# Access Compliance Report

## Public Rights-of-Way

### (Curb Ramps)

Intersection ID: 11258	Main Street: CLOVER_HILL_LN	Cross Street: STEPPING_STONE_DR	Location: SE
ADA ID: 64711FEDAE57	Ramp Type: Directional1	Initial Pass/Fail: Fail	Overall Compliance: No
		Severity Score: 13.75

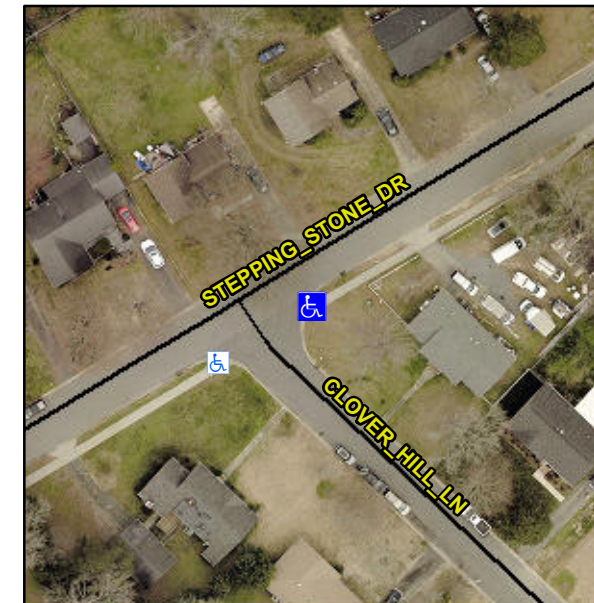
**R304.5.3**

Compliance	Description	Data	Compliance	Description	Data
N/A	Ramp Length (in)	206.0	N/A	Grade Break?	N/A
Yes	Ramp Width (in)	60.0	N/A	Grade Break Slope (%)	0.0
Yes	Ramp Slope (%)	9.7	N/A	Grade Break XSlope (%)	0.0
No	Ramp XSlope (%)	2.3			
N/A	Flare Type LT	N/A	N/A	Flare Type RT	N/A
N/A	Flare Slope LT (%)	N/A	N/A	Flare Slope RT (%)	0.0
N/A	Flare Traversable LT?	N/A	N/A	Flare Traversable RT?	N/A
N/A	Landing Length (in)	0.0	N/A	DWS Provided?	N/A
N/A	Landing Width (in)	0.0	N/A	DWS Contrast?	N/A
N/A	Landing Slope (%)	0.0	N/A	DWS Length (in)	N/A
N/A	Landing X Slope (%)	0.0	N/A	DWS Full Width?	N/A
N/A	Landing Curb? (Y/N)	N/A	N/A	DWS Offset LT (in)	N/A
N/A	Shared Landing?	N/A	N/A	DWS Offset RT (in)	N/A
N/A	Gutter Ponding?	0.0	N/A	Gutter Slope (%)	N/A
N/A	Gutter Lip Ht (in)	0.0	N/A	Gutter X Slope (%)	N/A
N/A	Painted X Walk1?	No		Road Slope (%)	3.6
	X Walk 1 Direction	To SW		Road X Slope (%)	3.0
	X Walk 1 Width (in)	N/A		Clear Space?	N/A

**Remove & Replace Entire Ramp.**
